Report on HS2 Ltd's Bowood Lane Mitigation site

HS2 Responses shown in Green

Fig 1

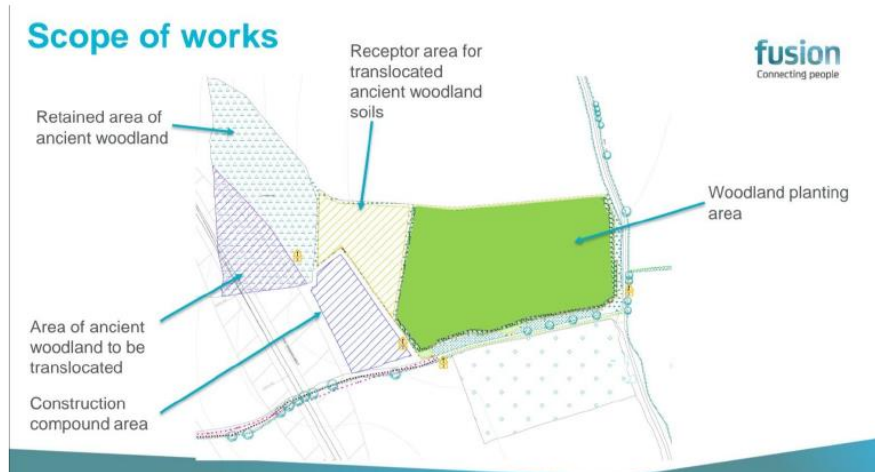
The map in Fig 1 shows the parcels of land involved.

The areas of importance to this report are: "Receptor area for translocated ancient woodland soils", "Woodland planting area" and Jones' Hill Wood ("Area of ancient woodland to be translocated" and "Retained area of ancient woodland") itself.
